The proposed zoning district has a setback measured from an existing or proposed future curbline. The location of the curbline on existing streets is depicted correctly on the current site plan.

Resolved Issues

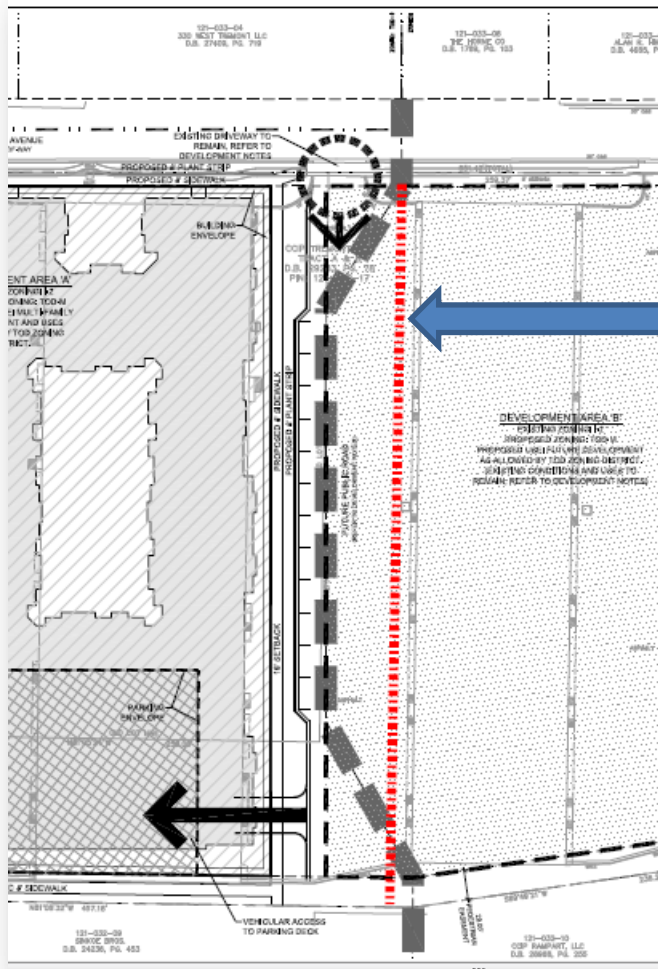
2. CDOT recommends that the proposed north-south street connection align with the existing half street that currently exists on the other side of W. Tremont Ave. See figure on next page. This development could propose an interim condition to maintain the existing driveway location to serve the existing use (**without constructing the street at this time as shown currently**) until such time that the site plan for Development Area "B" is determined. At that time, the necessary right of way should be dedicated and the entire cross section of the roadway shall be constructed. CDOT recommends that "note B" under "Access" be revised to reflect the proper alignment as discussed. In addition, revise the note to state that the public road shall be constructed at such time any building in area B is redevelopment or changes uses.

CDOT requests this alignment
